LARSON RIVER ROAD AUTO STORAGE

Project Title
LARSON RIVER ROAD STORAGE

Issue Set & Date:
PERMIT SET
09/23/2022

City Comments 09/01/2022 TCS

PAVING, HORIZONTAL CONTROL AND WATER PLAN

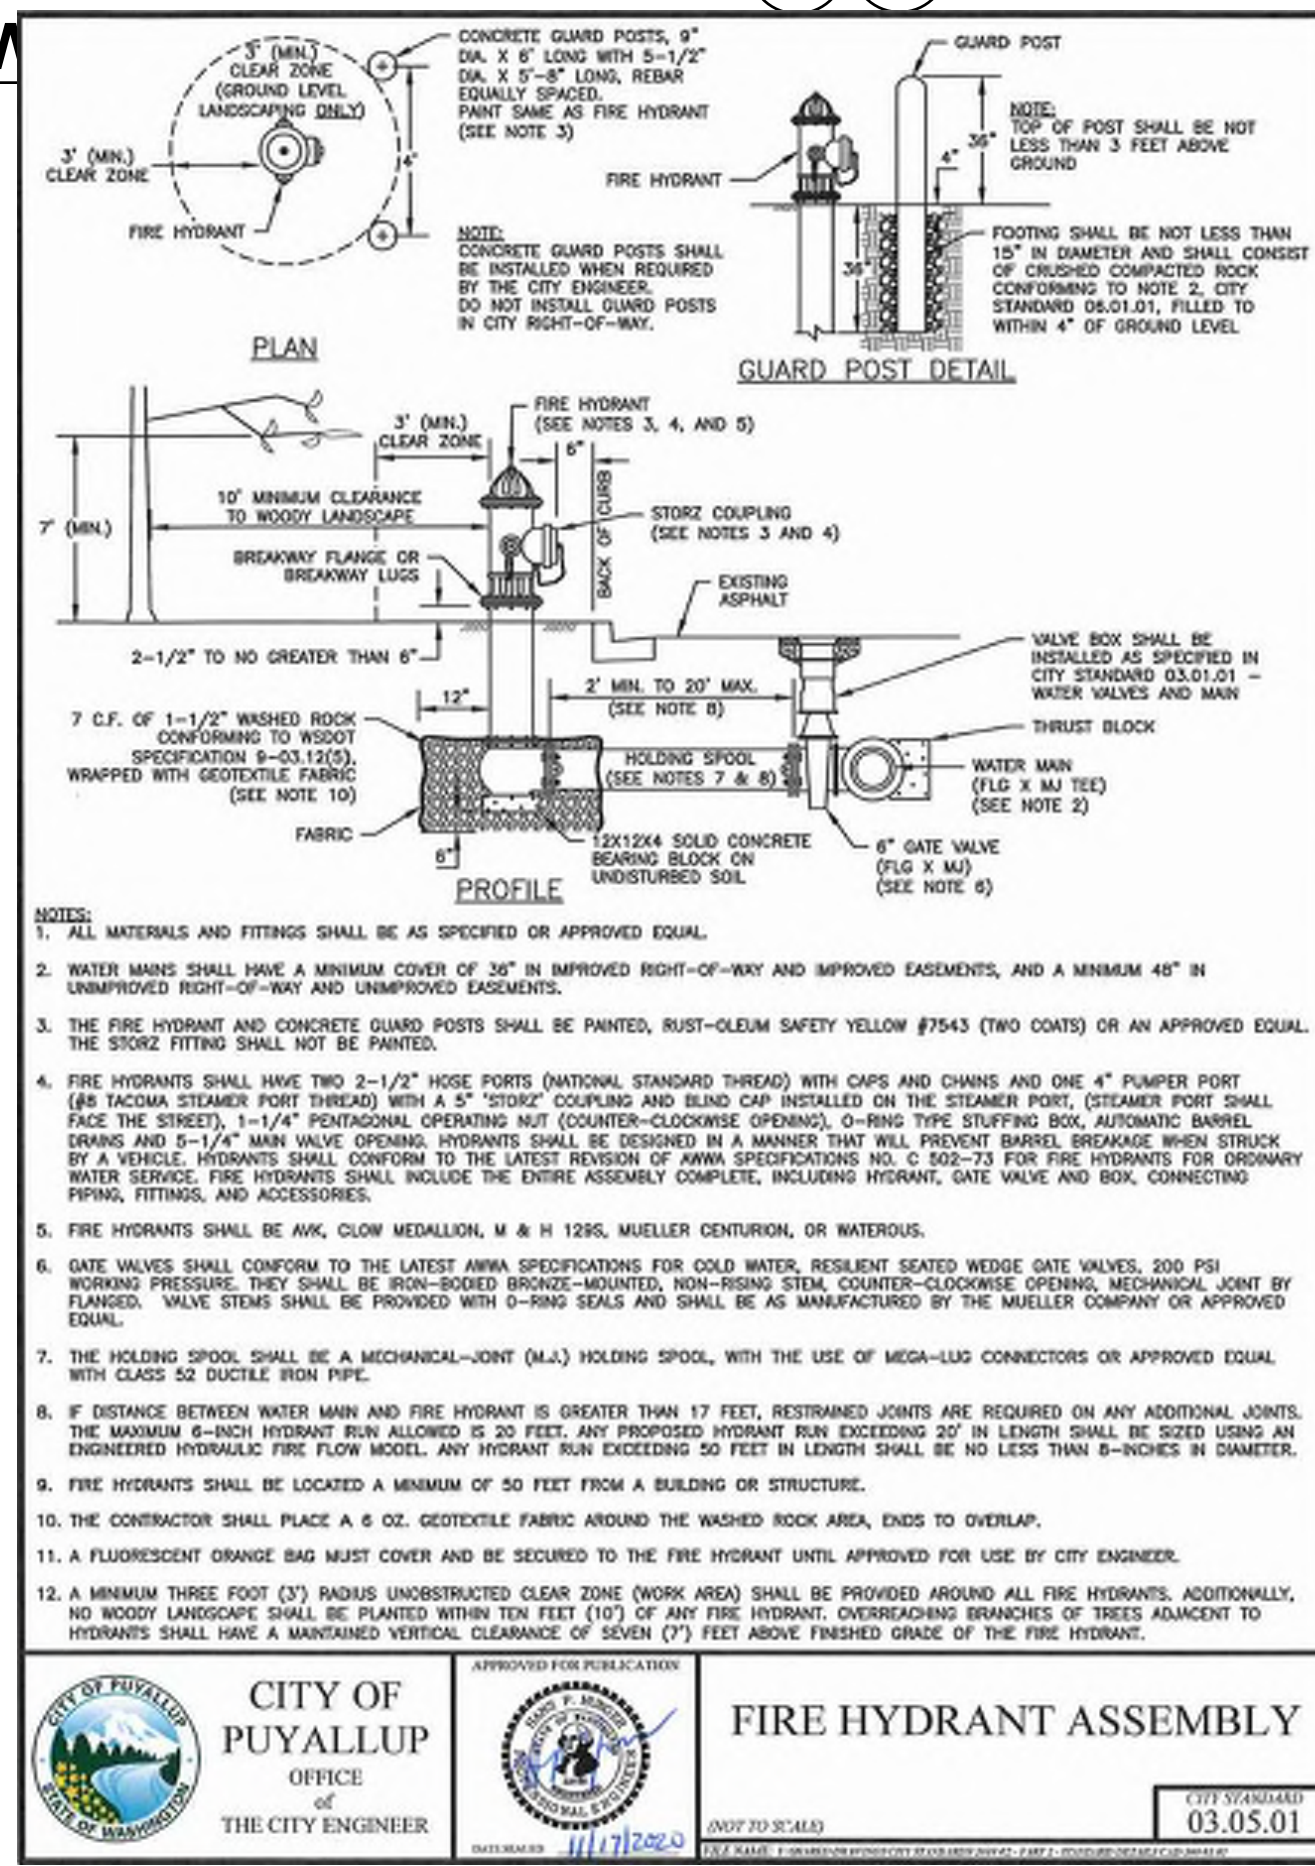
Sheet C2.0 - Is a hydraulic model needed for this proposed hydrant?

Sheet C2.0 - Change hydrant tee call-out to read 1-8"x6" TEE, MxFL1-6" GATE VALVE FLMJ1-8" MJ PLUG/THRUST BLOCKING

Sheet C2.0 - Acquire a private water easement through this parcel

Sheet C2.0 - Call out private 8-inch ductile iron pipe

657LF 8" DI CL 52 (PRIVATE 8" DI) UNDEVELOPED PROPERTY HAS SAME OWNER AS OTHER PARCELS. NO EASEMENT NEEDED AT THIS TIME. IF CHANGE OF OWNERSHIP IN THE FUTURE THEN WATER EASEMENT MUST BE OBTAINED.

PAVING, HORIZONTAL CONTROL AND WATER PLAN

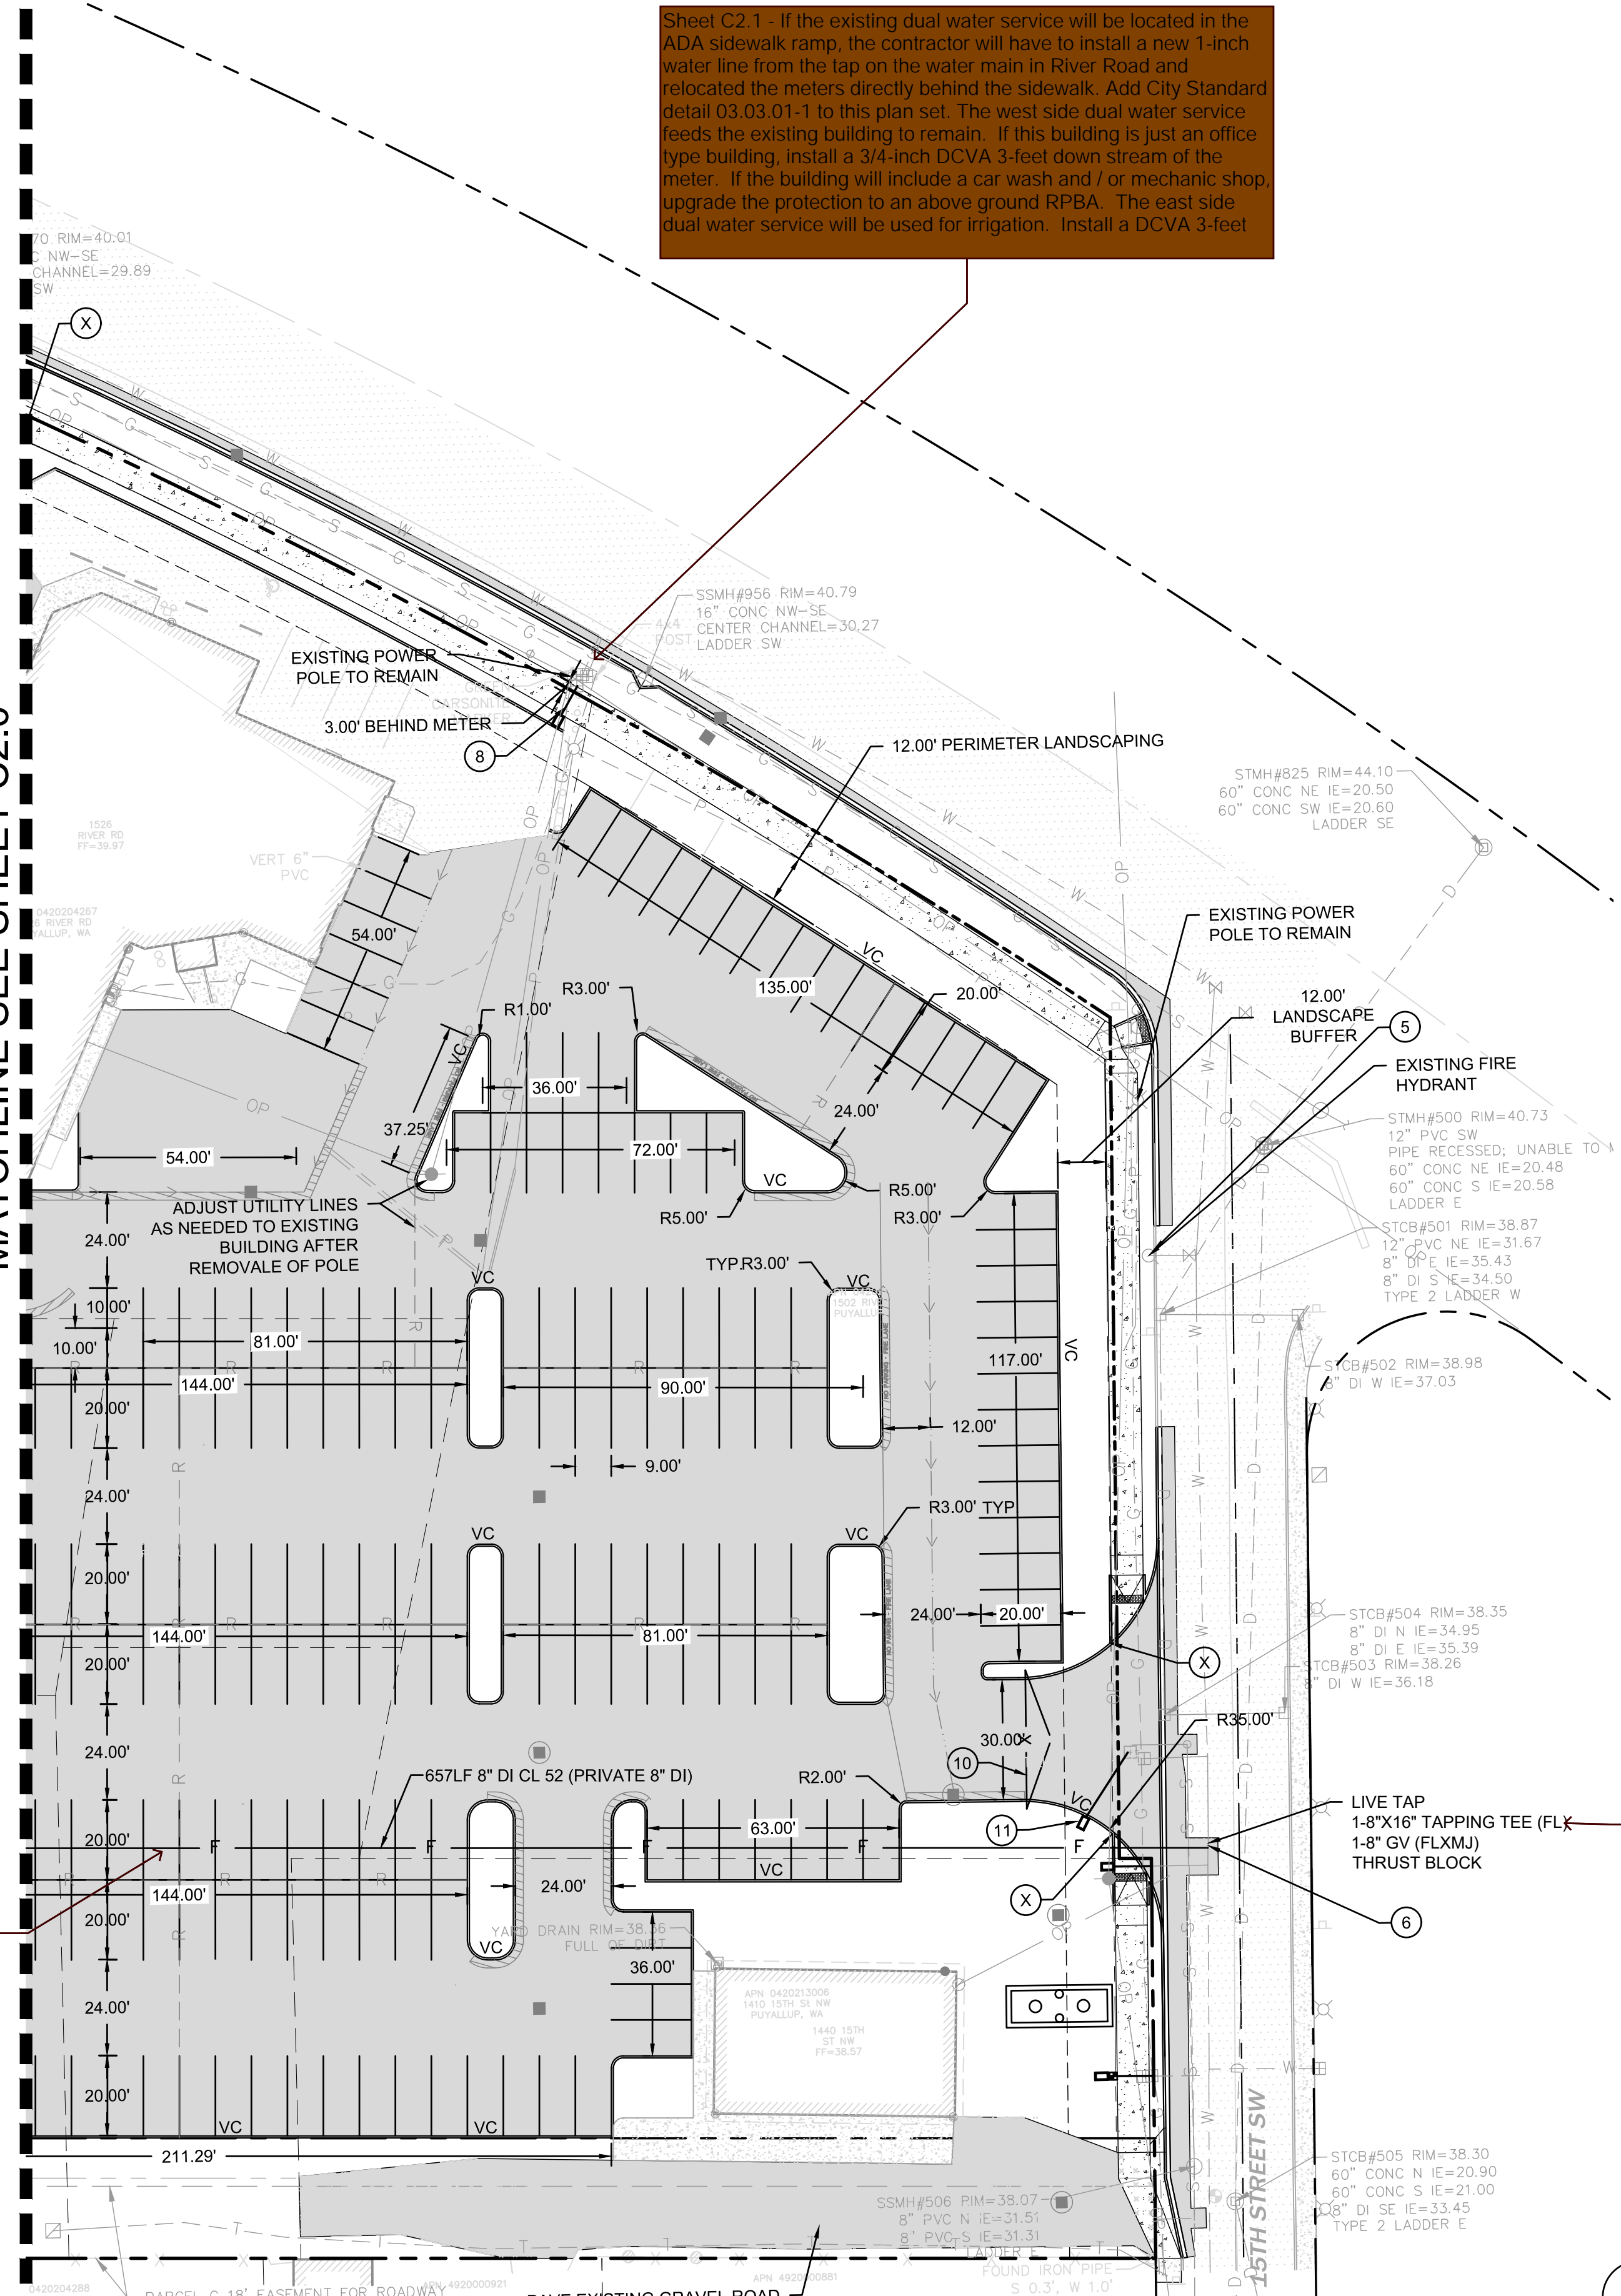
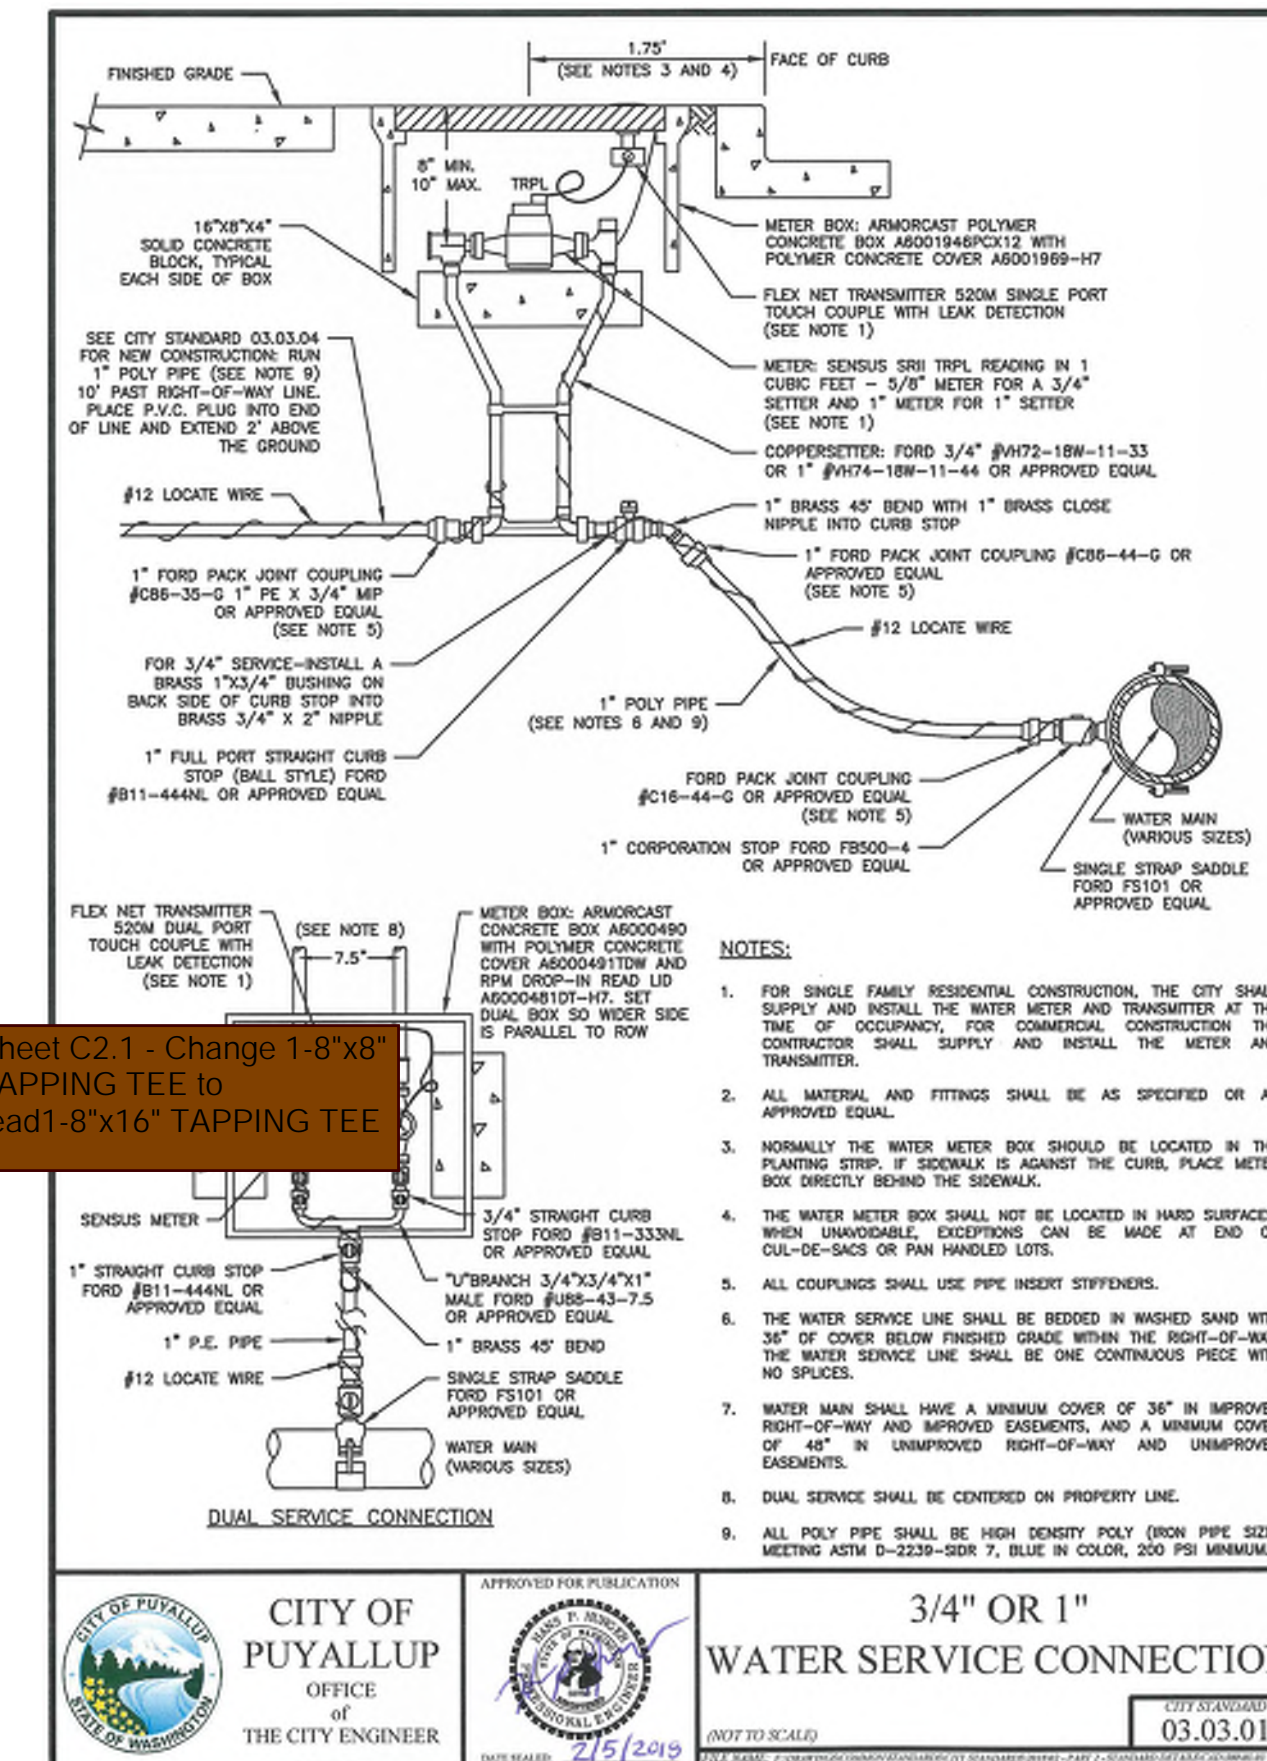
Sheet C2.1 - If the existing dual water service will be located in the ADA sidewalk ramp, the contractor will have to install a new 1-inch water line from the tap on the water main in River Road and relocate the meters directly behind the sidewalk. Add City Standard detail 03.03.01-1 to this plan set. The west side dual water service feeds the existing building to remain. If this building is just an office type building, install a 3/4-inch DCVA 3-feet down stream of the meter. If the building will include a car wash and / or mechanic shop, upgrade the protection to an above ground RPBA. The east side dual water service will be used for irrigation. Install a DCVA 3-feet

Sheet C2.1 - Call out private 8-inch ductile iron pipe

Sheet C2.1 - Change 1-8"x8" TAPPING TEE to read 1-8"x16" TAPPING TEE
